# Revised Fan Ring Bracket Mounting Screws

M-263-006

(July 2008)

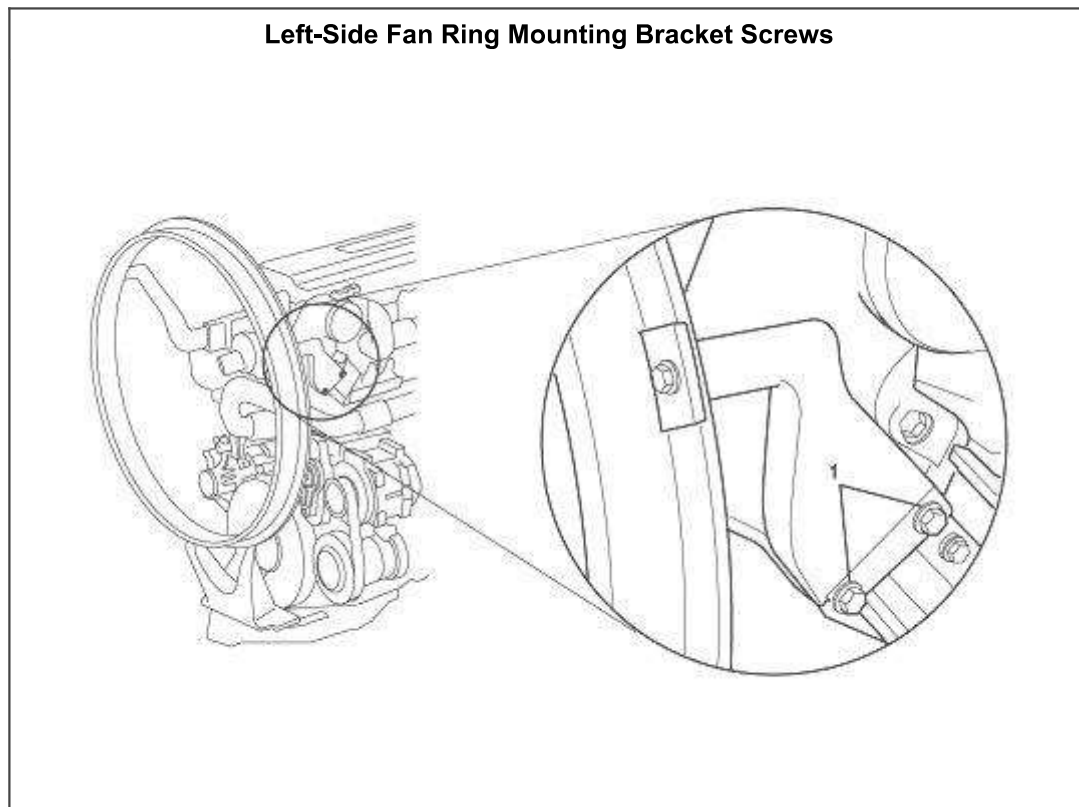
Effective on the dates shown below, a longer mounting screw (part number 945444) for the left-side fan ring mounting bracket was implemented into production on all CXU, CHU and GU model chassis equipped with MP7 or MP8 engines, replacing the previous screw (part number 64AM12).

The revised screw is 25 mm long, 5 mm longer than the previous screw. Should broken left-side fan ring bracket mounting screws be encountered on a CXU, CHU or GU model chassis manufactured prior to the above mentioned dates, replacement with the revised screw is recommended.

Key	Qty.	Part number	Description	Replaces
1	2	945444	Flange	64AM12

Torque specification for the revised bolt is 24 N•m (18 lb-ft).
